SECTION 00 9115
ADDENDUM NUMBER 5

DATE: August 11, 2016

Rochester City School District
 James Monroe High School
 164 Alexander Street
 Rochester, New York
 SED #: 26-16-00-01-0-107-029
 DWT #: 26-16-00-01-7-999-019

PROJECT: **RSMP - JAMES MONROE HIGH SCHOOL**
 PHASE 2A
 DRAWING TITLE: **SECTION AT INFILL FRAME SUPPORT**
 PROJECT NO: 1522
 DRAWN BY: MR
 SCALE: AS NOTED
 ISSUE DATE: 8/10/16
 REVISION DATE:

1 SECTION @ INFILL FRAME SUPPORT
S-01 SCALE: 3/4"=1'-0"

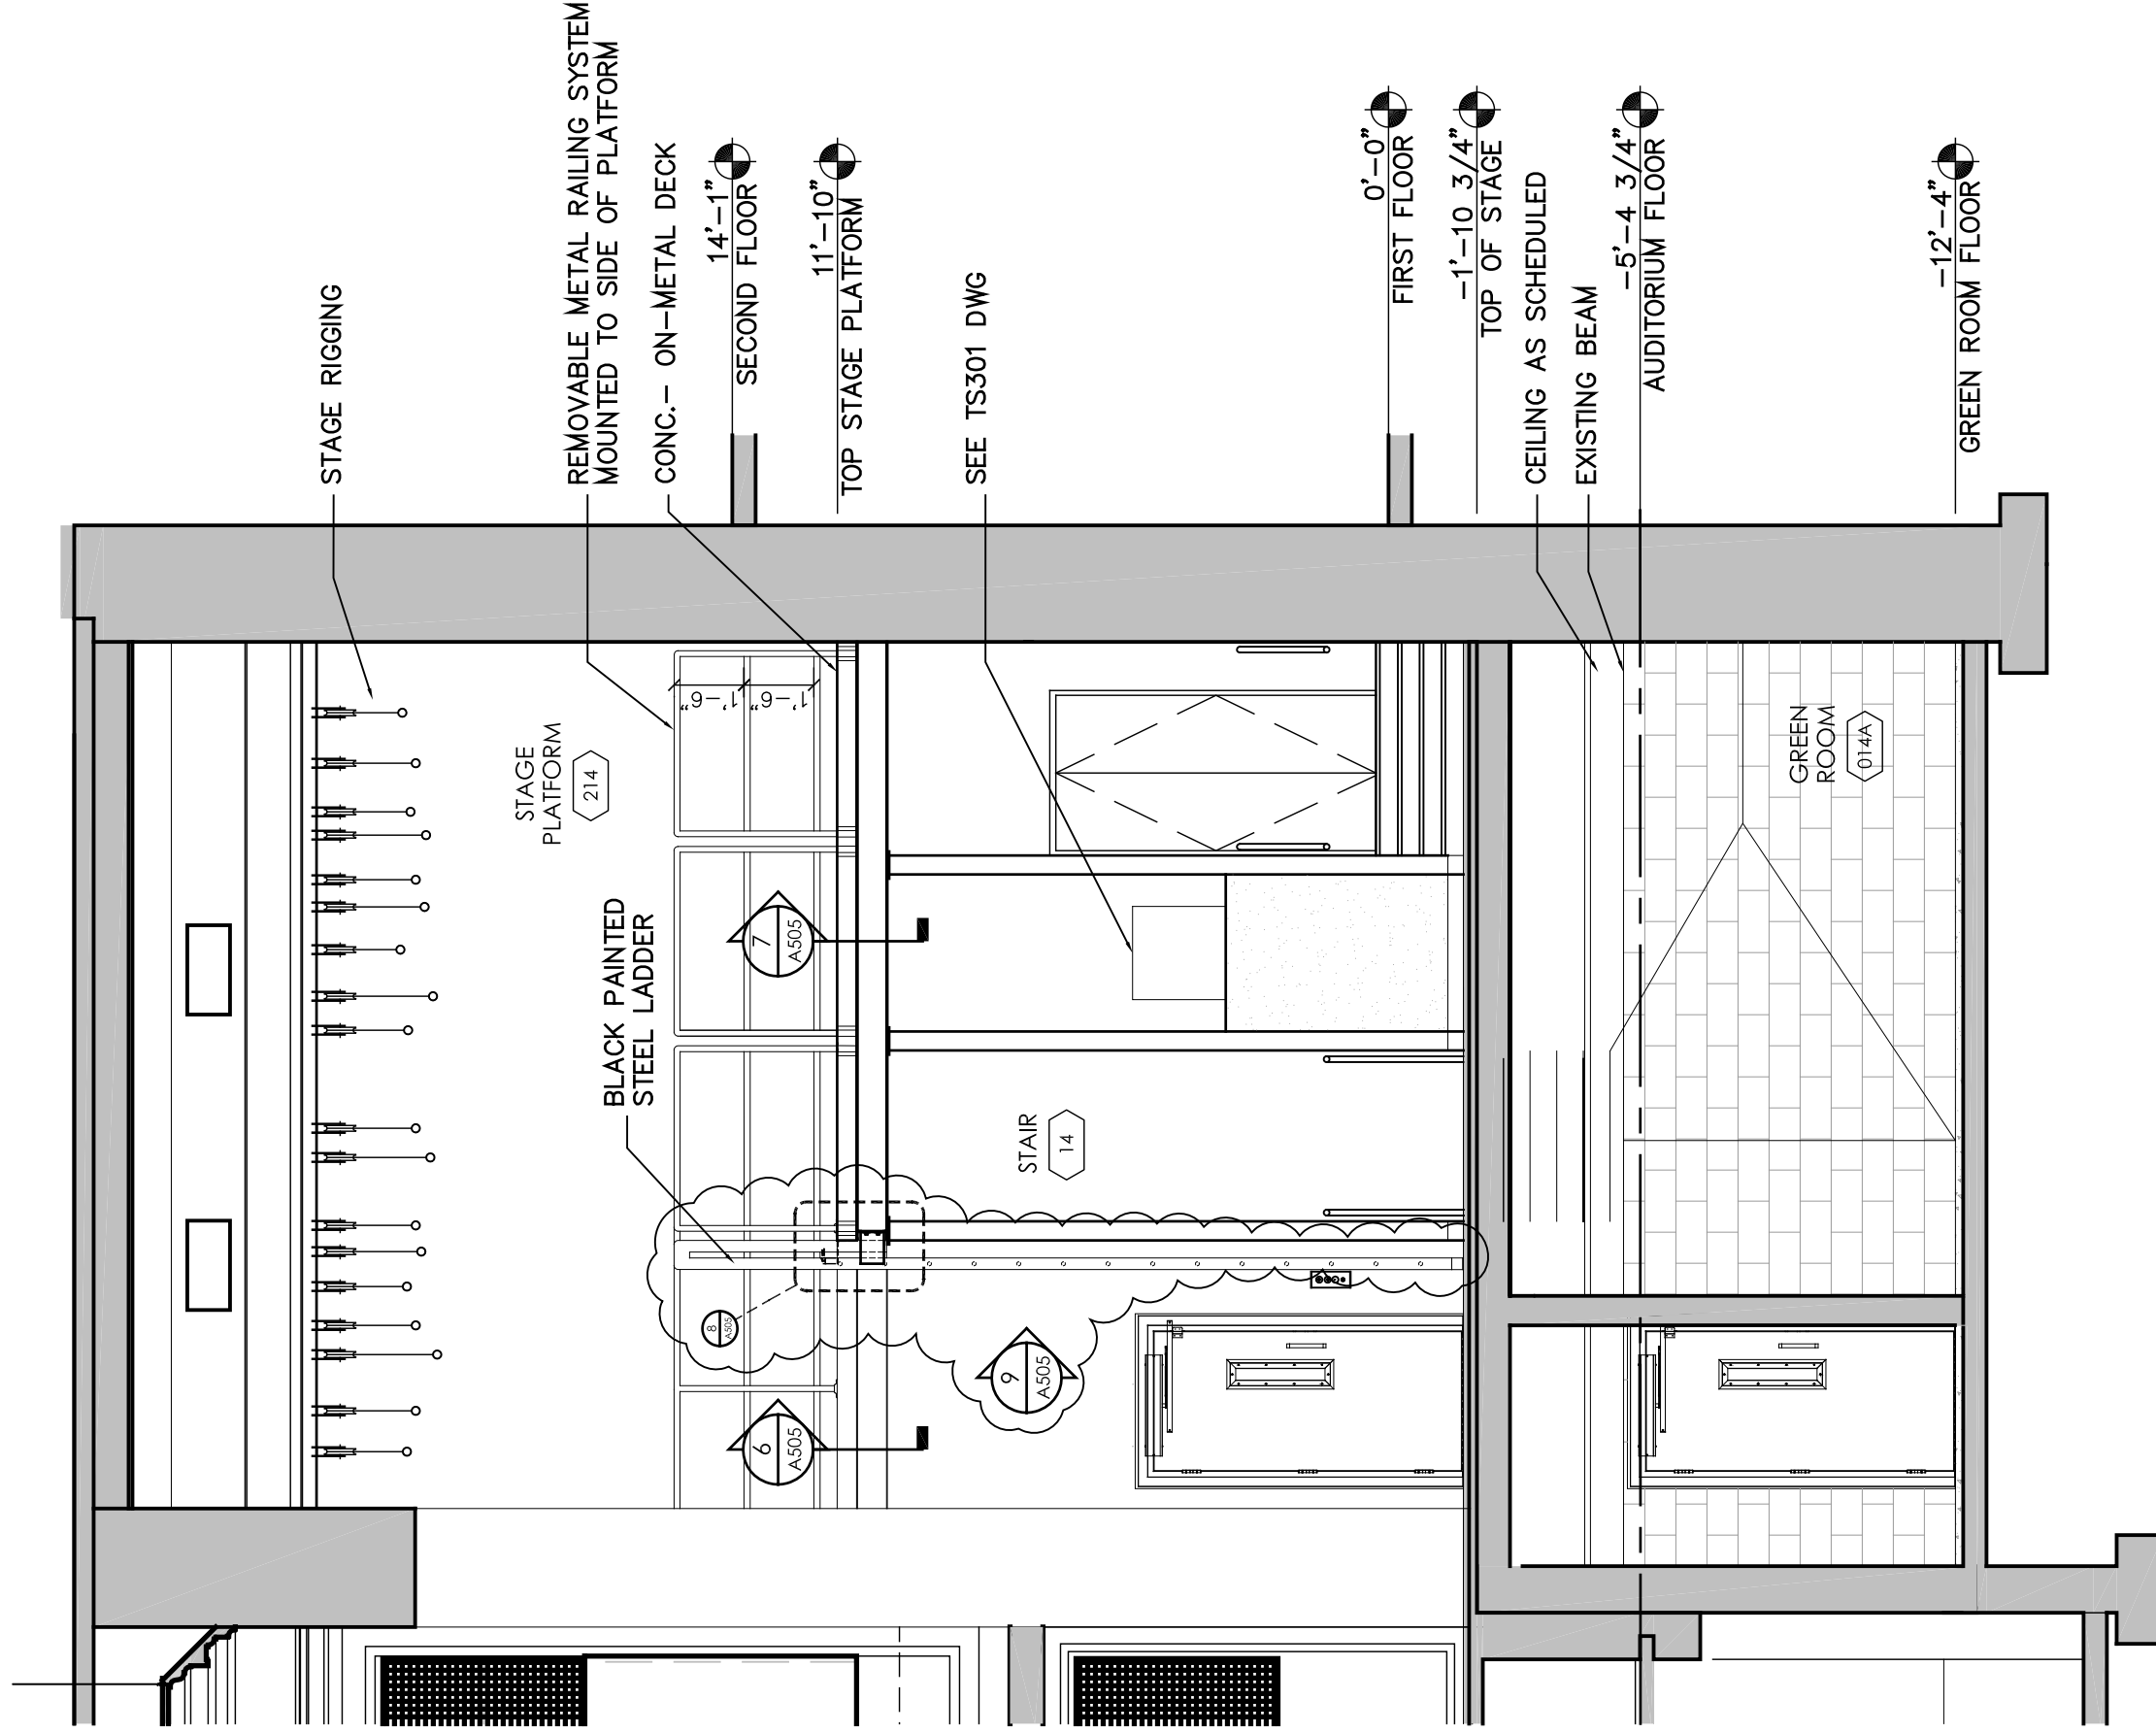
- A. Replace detail 4/A410 with the attached sketch ADD5-S-01.

1. SLAB INFILL ELEVATION VARIES AT DOOR OPENINGS. CONCRETE INFILL TO BE LEVEL WITH EXISTING TERRAZZO FLOOR FINISH.
2. PROVIDE POUR STOP @ ENDS OF FRAME SUPPORT.
3. PROVIDE FRAME SUPPORT ON EACH END OF CONCRETE DECK.
4. MAXIMUM SPACING OF STEEL FLOOR SUPPORT FRAMES SHALL NOT EXCEED 5'-0" O.C.
5. DETAIL IS SIMILAR AT NEW DOOR OPENINGS. REDUCE CONCRETE SLAB THICKNESS TO 5". TOP OF SLAB SHALL BE FLUSH WITH TOP OF CLASS ROOM EXISTING STRUCTURAL SLAB
6. CONTRACTOR SHALL PROVIDE A SMOOTH 3/8" THICK MORTAR BED AT PLATE INTERFACE.

8 LADDER DETAIL
 A505 SCALE: 1 1/2" = 1'-0"

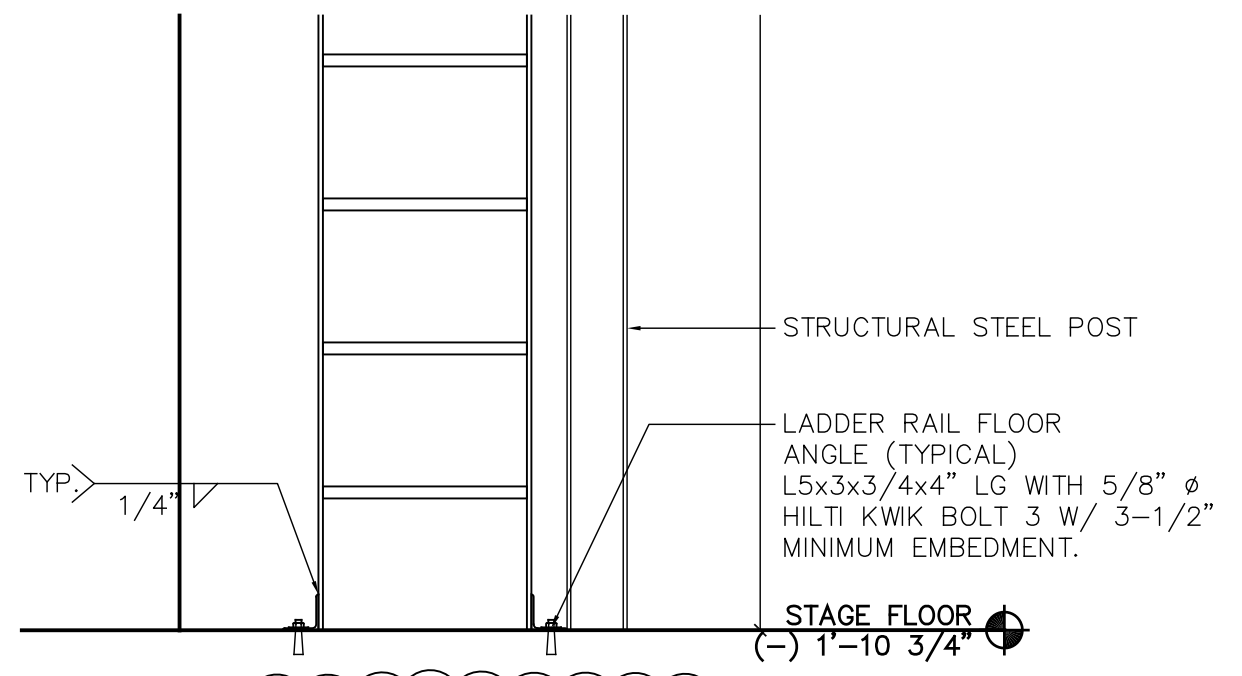
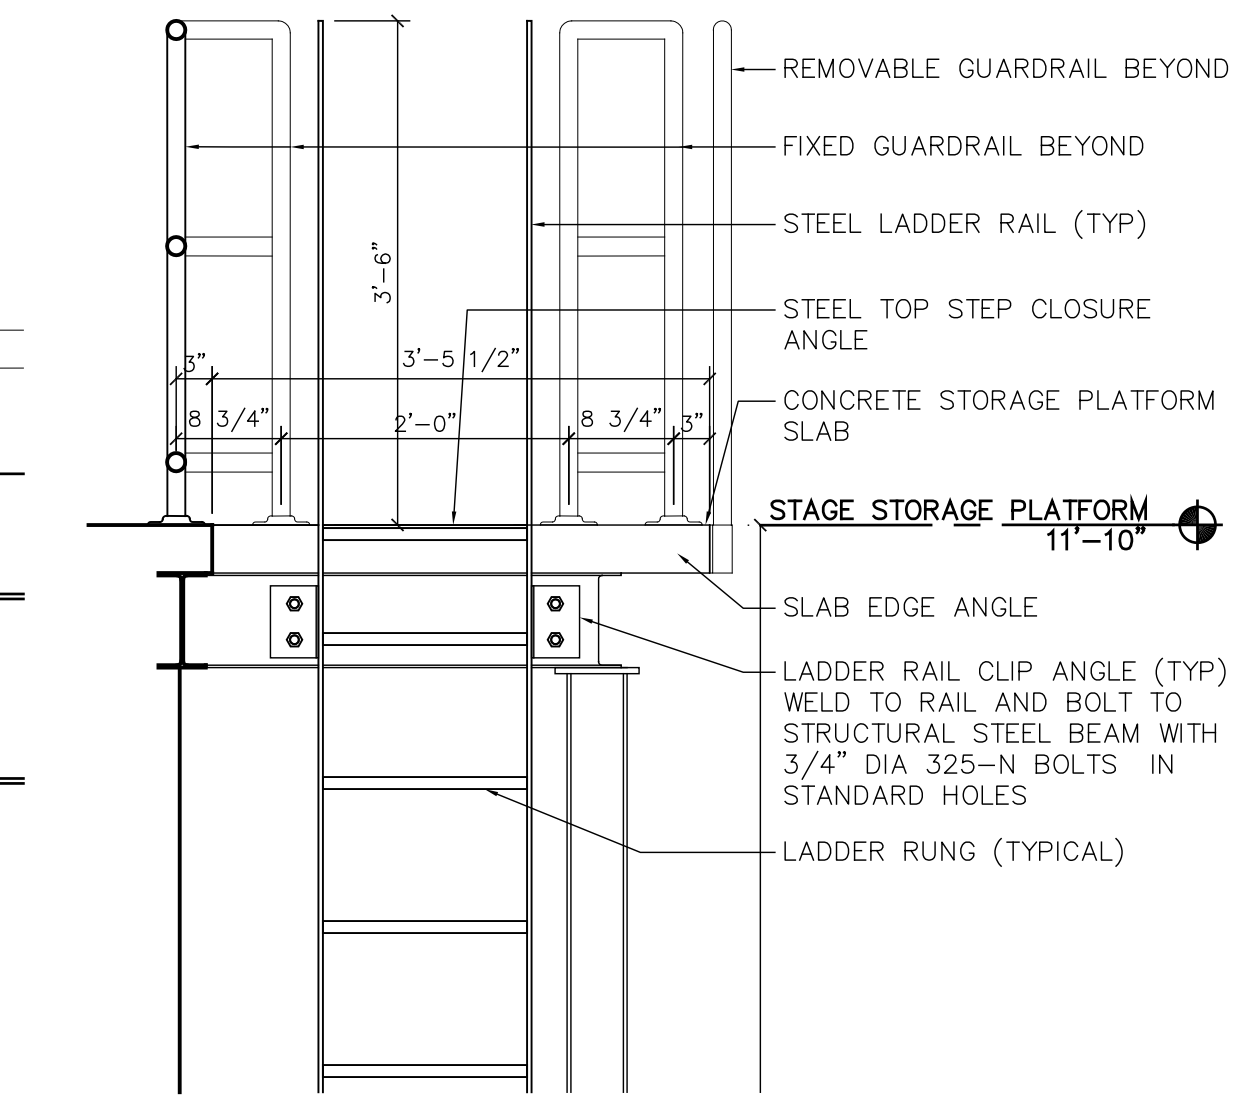
- A. Detail 3: Add note 1 as follows:
“Provide 3x3 steel posts, 48” o.c., with bottom plate and (2) expansion bolt anchors into concrete and masonry, extending up to underside of top track of all light gauge metal stud partial height walls.

PARTIAL THIRD FLOOR PLAN
 A118 SCALE: 1/8" = 1'-0"

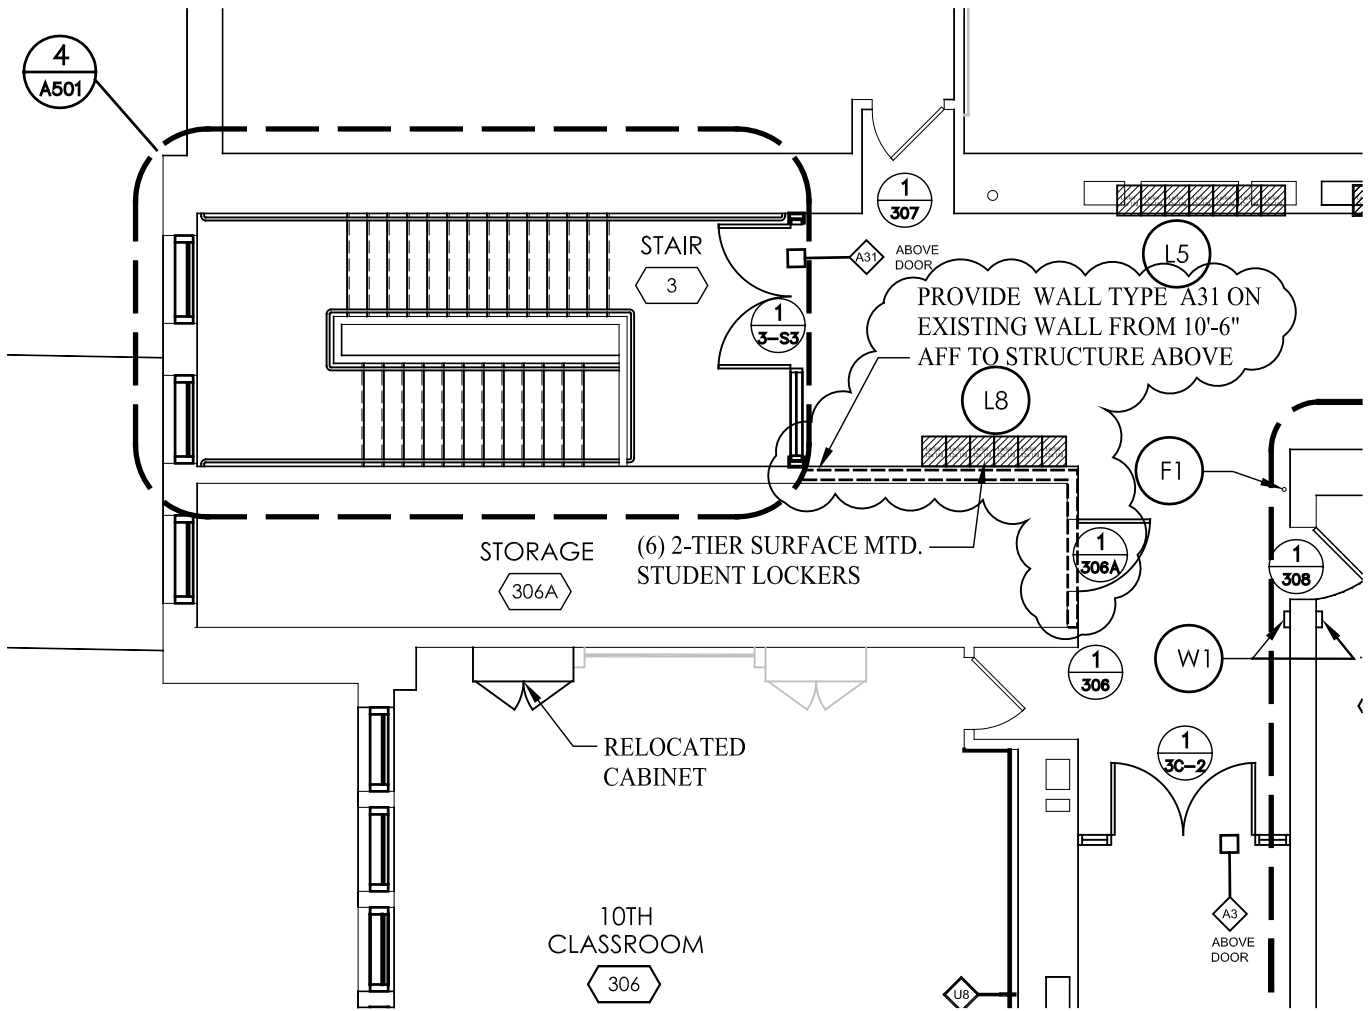
- A. Extend corridor wall of 306A to structure above per sketch ADDSK-A-11.

1 PARTIAL BASEMENT REMOVAL PLAN
 1/8" = 1'-0"

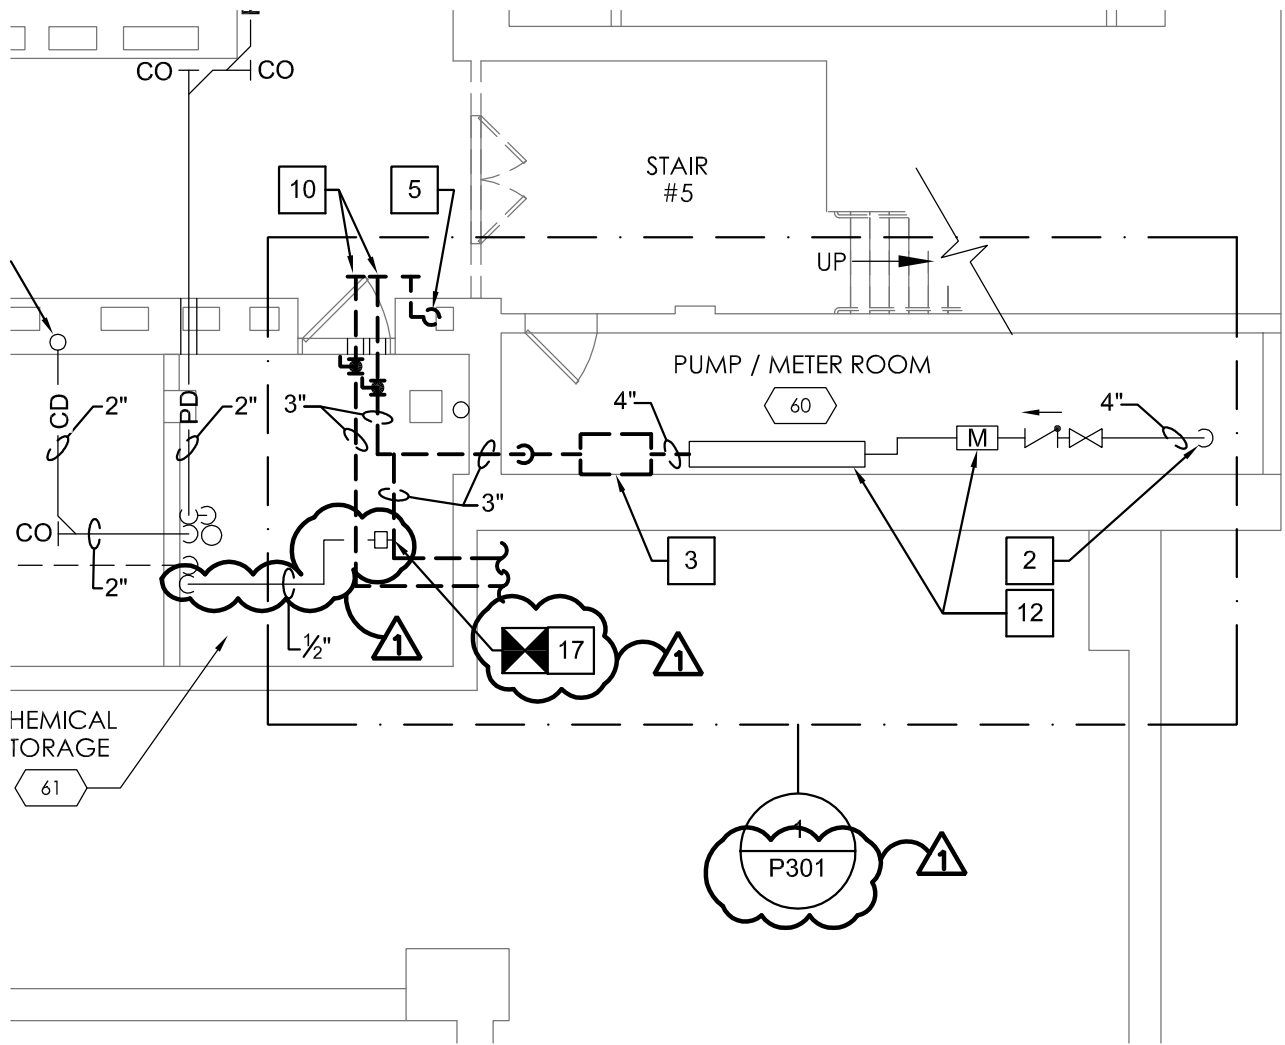
- A. Change ½” C. piping with trap primer as existing to remain. “Refer to Sketch ADD5–SK-P-09”.
- B. Correct enlarged plan number. “Refer to Sketch ADD5–SK-P-09”.
- C. Add keyed note 17. “Refer to Sketch ADD5–SK-P-09”.

1 PARTIAL BASEMENT PLUMBING PLAN
 1/8" = 1'-0"

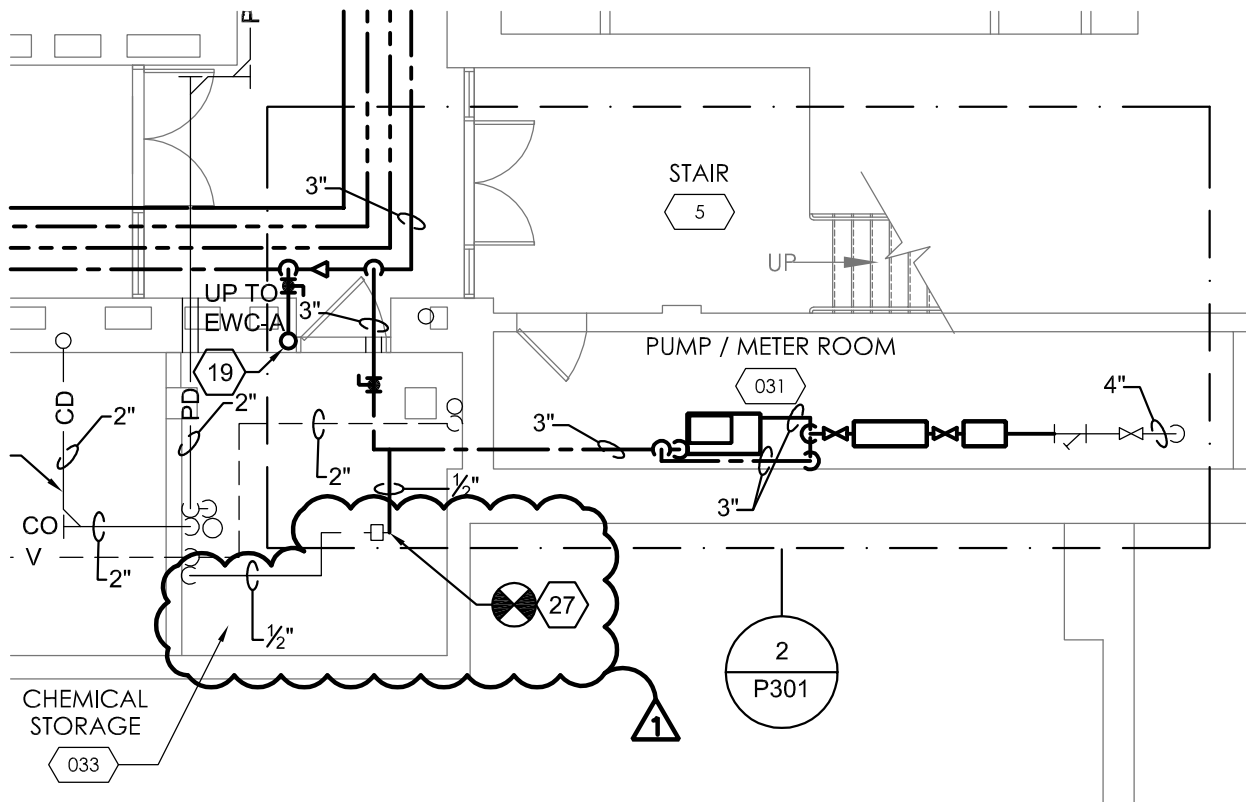
- A. Add: Connect to existing ½” C. piping with trap primer to Chemical Storage room 33. “Refer to Sketch ADD5–SK-P-10”.
- B. Edit keyed notes 26 and 25. “Refer to Sketch ADD5–SK-P-10”.

- 24. PROVIDE EXPANSION COMPENSATOR ON C., H., HWR, & GAS PIPING.
- 25. PROVIDE 3" V. PIPING UP.
- 26. NOT USED.
- 27. CONNECT 1/2" C. TO 1/2" C. AT THIS POINT.
- 28. CONNECT AND PROVIDE 3" ST. PIPING UP/DN. RELOCATE FOR STEEL COLUMN x(FOUR) 4 FLOORS.
- 29. PATCH/REPAIR CONCRETE FLOOR TO MATCH ARCHITECTURAL SURFACE FINISH.
